SERVICE BULLETIN

APPLICABILITY: 2018-19MY Legacy and Outback

NUMBER: 10-91-19

SUBJECT: Heater (HVAC) Control Assembly Surface Peeling

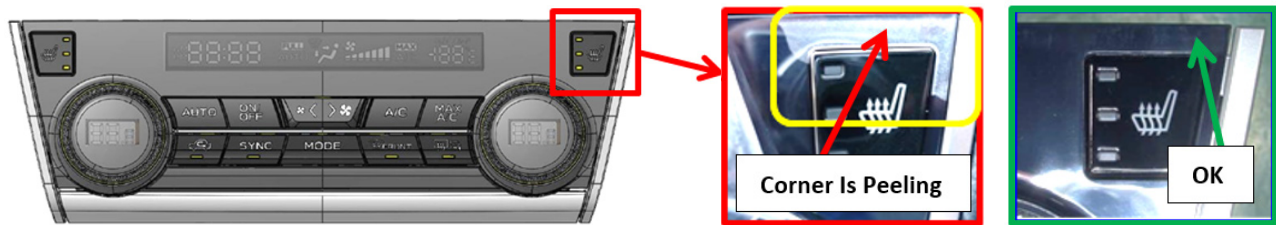
This bulletin announces availability of a new heater control assembly to address a small number of customer concerns about peeling of the surface finish / coating. Insufficient clearance between the heater control and the audio unit face above may cause a whitish or cloudy appearance and peeling to develop as shown below.

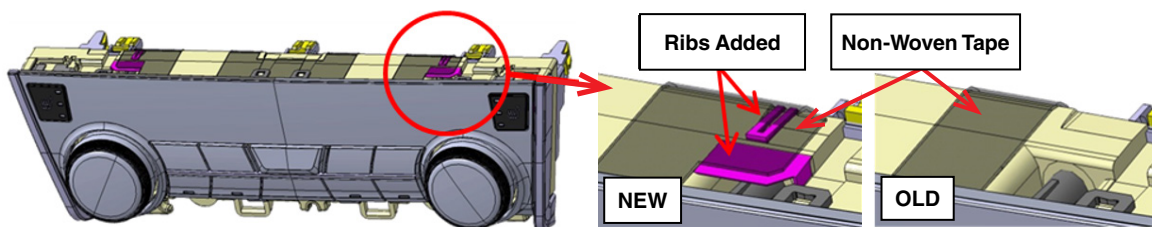
The new part has a rib added along with additional non-woven tape to provide the necessary clearance as shown in the new / old comparison illustrations provided below.

The part number for the new heater control assembly is: **72311AL32A**.
